July 11, 2022

RNI Ace Class IIIb Exploration and Production Waste Landfill Disposal
GeoStrata Project No. 524-099

RE: Request for Information – RNI Ace Class IIIb Exploration and Production Waste Landfill

LOCATION	DUCHESNE COUNTY, UTAH	B-4
PROJECT	ACE DISPOSAL LANDFILL	
TITLE	PLAN & PROFILE POND 6 EAST TO WEST	NO

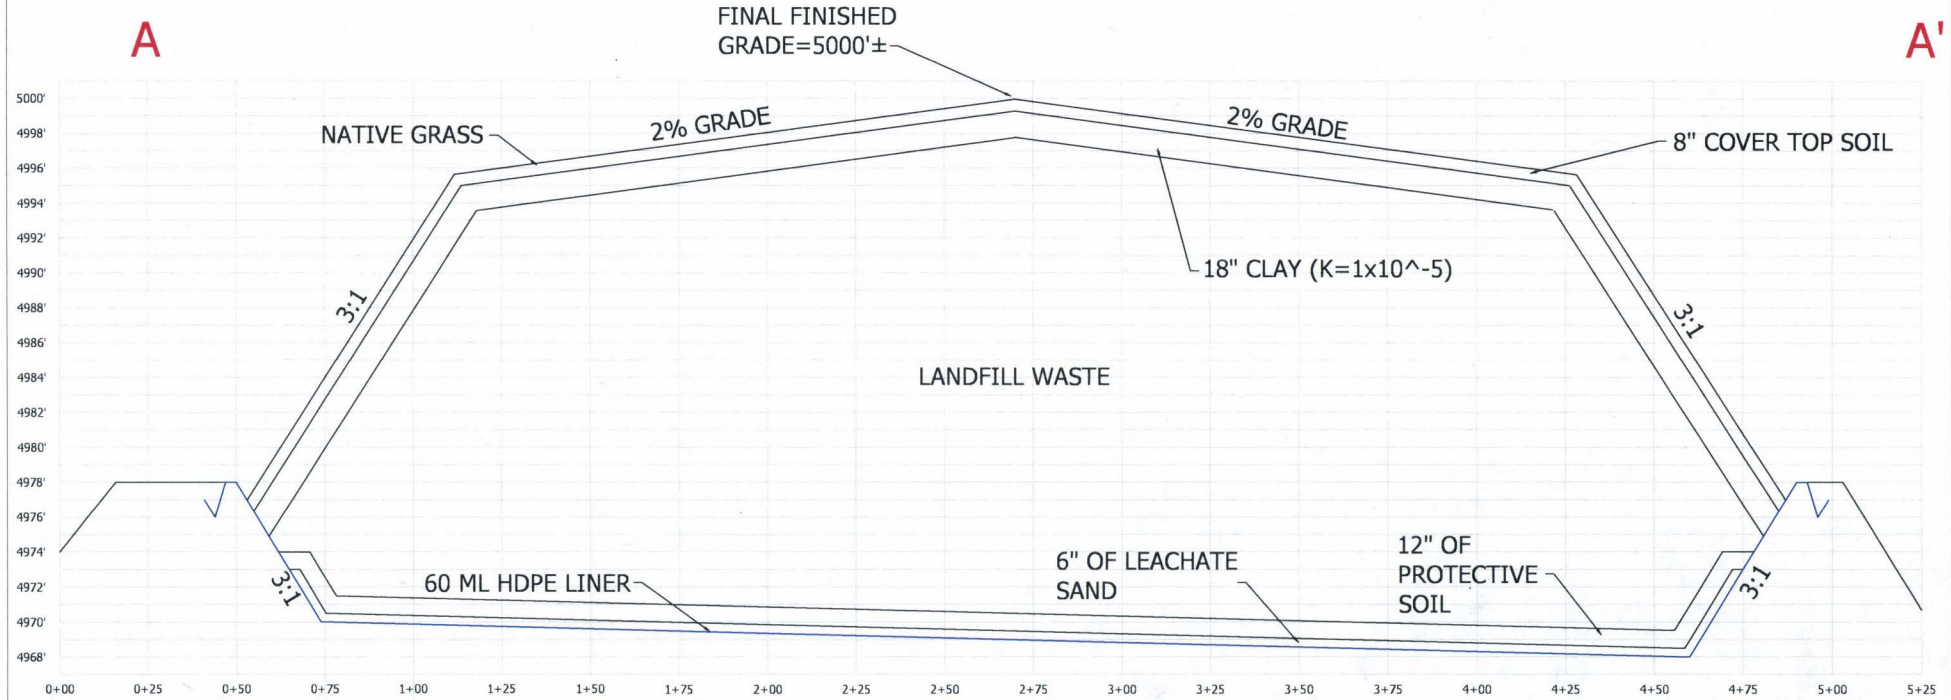
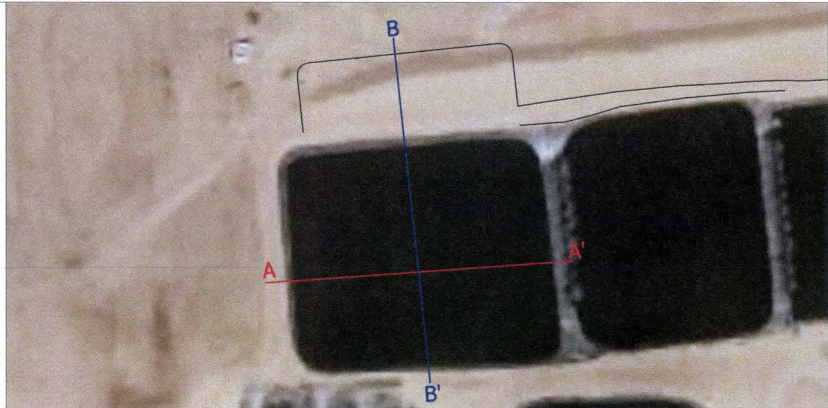
Comment 1: *Part II, 3.2.3 – Waste Disposal – Unless Ace Landfill can justify the use of just 12” protective layer of drain sand, the Division recommends using at least an 18” to fully protect the liner before any waste is disposed of. Please make changes to Drawings B-4 and B-5 to reflect these changes.*

Comment 3: *Part III, 3.2 – Design of the Final Cover. Please provide an updated evapotranspiration (ET) cover design by specifying a clay layer of adequate thickness and covering it with more topsoil to provide an effective and lasting landfill cover. Please make changes to Drawings B-4 and B-5 to reflect these changes.*

(a) The Division disagrees with the use of just 6 inches of a clayey soil layer placed on the waste prior to placing the topsoil layer. A thin layer such as this could not be compacted. ET covers, such as discussed in Part III, Section 3.2., have not been shown effective when designed less than 40" thick, and most are thicker.

Response: Drawings B-4 and B-5 have been updated to meet this request of using 18 inches of drain sand. See attached permit drawings and incorporate them into the final permit.

As part of this request the design drawings have been updated to show a final cover based on the Standard Design. This updated design includes 18 inches of soil that have permeability of less than 1×10^{-5} in addition to the 8 inches of soil to support vegetative growth.
